# Access Compliance Report

## Public Rights-of-Way

Intersection ID: 45828	Main Street: CHRISTENBURY_HILLS_LN	Cross Street: GRAYS_RIDGE_DR	Location: NW
ADA ID: 6C407AF824B9	Ramp Type: PerpDiag	Initial Pass/Fail: Fail	Overall Compliance: No
Severity Score: 30			
Codes/Mitigation Info/Possible Solution		Field Measurements/Component Compliance

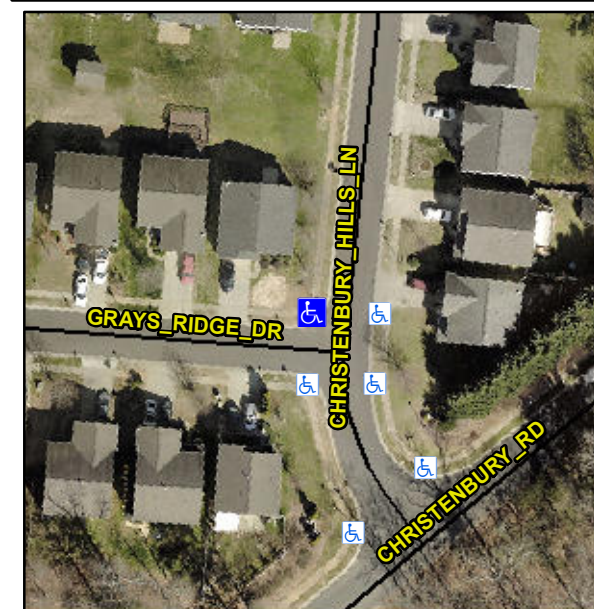
**Not Found, R304.5.1, R304.2.2**

Compliance	Description	Data	Compliance	Description	Data
N/A	Ramp Length (in)	47.5	No	Ramp Slope (%)	10.5
No	Ramp Width (in)	34.0	Yes	Ramp XSlope (%)	1.7
N/A	Flare Type LT	N/A	N/A	Flare Type RT	N/A
N/A	Flare Slope LT (%)	N/A	N/A	Flare Slope RT (%)	N/A
N/A	Flare Traversable LT?	N/A	N/A	Flare Traversable RT?	N/A
N/A	Landing Length (in)	N/A	N/A	DWS Provided?	N/A
N/A	Landing Width (in)	N/A	N/A	DWS Contrast?	N/A
N/A	Landing Slope (%)	N/A	N/A	DWS Length (in)	N/A
N/A	Landing X Slope (%)	N/A	N/A	DWS Full Width?	N/A
N/A	Landing Curb? (Y/N)	N/A	N/A	DWS Offset (in)	N/A
N/A	Shared Landing?	N/A			
N/A	Gutter Ponding?	N/A	N/A	Gutter Slope (%)	N/A
N/A	Gutter Lip Ht (in)	N/A	N/A	Gutter X Slope (%)	N/A
N/A	Painted X Walk1?	No	N/A	Painted X Walk2?	No
	X Walk 1 Direction	To S		X Walk 2 Direction	To E
N/A	X Walk 1 Width (in)	N/A	N/A	X Walk 2 Width (in)	N/A
	X Walk 1 Slope (%)	3.5		X Walk 2 Slope (%)	0.4
	X Walk 1 X Slope (%)	0.2		X Walk 2 X Slope (%)	2.6

**Remove & Replace Curb Ramp With Two New Directional Ramps or Equivalent.**
